Takes of Marine Mammals Incidental to Specified Activities; Taking Marine Mammals Incidental to an Exploration Drilling Program Near Camden Bay, Beaufort Sea, Alaska; Notice

ACTION: Notice; issuance of an incidental harassment authorization.

A Notice of Proposed IHA published in the **Federal Register** on November 7, 2011 (76 FR 68974) for public comment. During the 30-day public comment period, NMFS received nine comment letters from the following: the Alaska Eskimo Whaling Commission (AEWC); Inupiat Community of the Arctic Slope (ICAS); the Marine Mammal Commission (MMC); State of Alaska Department of Natural Resources; Consumer Energy Alliance; Resource Development Council; the North Slope Borough (NSB); Shell; and Alaska Wilderness League (AWL), Audubon Alaska, Center for Biological Diversity, Defenders of Wildlife, Earthjustice, Natural Resources Defense Council, Northern Alaska Environmental Center, Oceana, Pacific Environment, Resisting Environmental Destruction on Indigenous Lands, Sierra Club, the Wilderness Society, and World Wildlife Fund (collectively "AWL"), along with an attached letter from David E. Bain, Ph.D.

Figure 1. Band levels for the Kulluk during drilling.

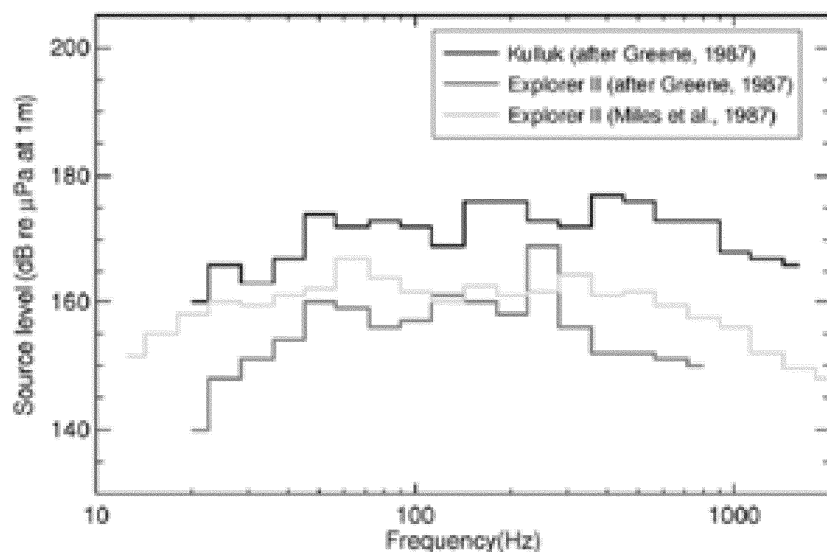
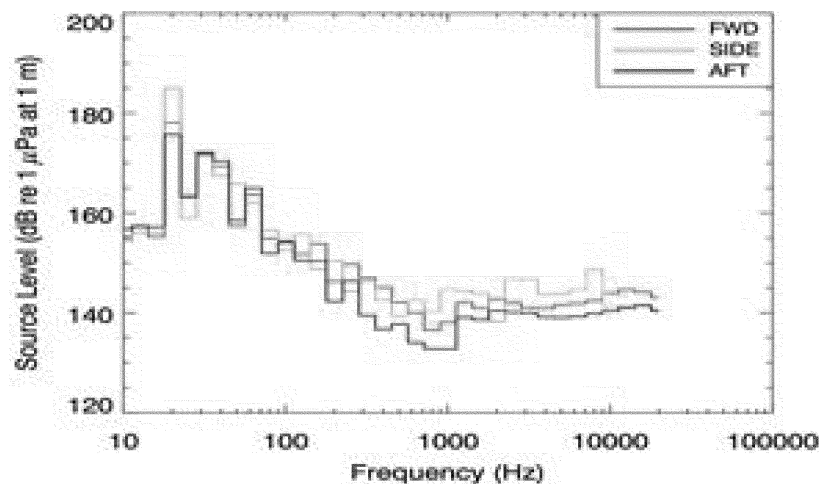
Comment 4: The MMC and AWL question the source levels and harassment zones for the two drillships. If the source levels for the *Kulluk* and *Discoverer* are nearly identical, then why is there a four-fold difference in the size of the corrected harassment zones for the two drilling vessels?

Response: Differences in sound propagation from the two rigs are real and are caused by differences in the design of the two vessels. While the broadband source levels for the

Discoverer and *Kulluk* may be similar, their spectral properties differ considerably. Acoustic modeling considers the source levels in 1/3-octave frequency bands. Figures 1 and 2 show the band levels for both drillships during drilling. Of key importance are the significantly lower levels of the *Discoverer* in the 50 to 500 Hz bands that propagate well in the relatively shallow waters of these drilling operations. While the *Discoverer* apparently has higher band levels below 50 Hz, this energy is more rapidly attenuated than higher frequency sound energy. This characteristic of sound propagation in shallow waters leads to predominantly mid-frequency sounds (50–500 Hz) dominating the acoustic field at distance from the drillships. A further consideration is that the *Kulluk* source levels are known to include contributions from support vessels, and much of the mid-high frequency band energy in its source levels may not originate entirely from the drillship itself, as acknowledged by Greene (1987). The *Discoverer* source level measurements by Austin and Warner (2010) were made at closer distances and do not include significant contributions from other vessels. The *Kulluk*'s modeled sound footprint may be an overestimate as a result, but we cannot quantify by how much since the relative contribution of vessel noise to its source level measurements is unknown. The source level for the *Discoverer* was measured, though not in the Beaufort Sea, and those measurements were used to model propagation in the Beaufort Sea environment. Regardless of which drill rig is used by Shell in the Beaufort Sea in 2012, the IHA requires Shell to conduct sound source verification (SSV) and characterization tests on all equipment used.

Figure 3. Sound speed profile used in drill rig modeling.

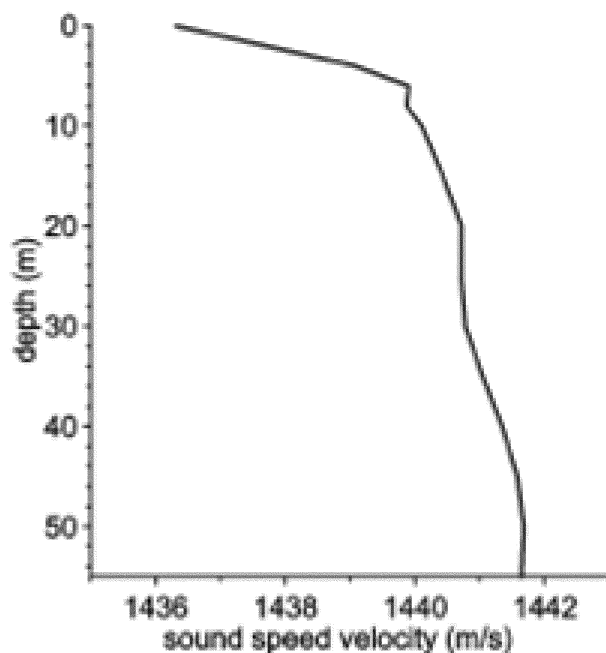
Comment 26: Dr. Bain states that the correction factor of 1.5 applied to the distance to the 120 dB contour is inadequate to conservatively account for the variability.

Response: The concern raised here is that the sound speed profile used for acoustic modeling of drill rig noise may not account for changes to the salinity and temperature profile that could influence and create variability in sound propagation, and the resulting variability might lead to conditions in which model estimates would not be conservative. While significant structure can form in the sound speed profile, the profile used for this modeling study was taken from the GDEM database for the corresponding locations and timing (month of September was used). The specific profile chosen (see Figure 3) has increasing sound speed with depth over the full water column. This profile leads to upward acoustic refraction that causes propagating sounds to bend up, thereby reducing interactions with the seabed. This situation generally reduces acoustic transmission loss as a result of acoustic energy being lost due to reflection and scattering from the bottom. It is believed to produce longer propagation distances than the stratified profile that sometimes forms with warmer high speed water overlying cooler water. That profile would be downward-refracting and would lead to more bottom interaction and sound energy loss. Therefore, a correction factor of 1.5 is appropriate in this circumstance.
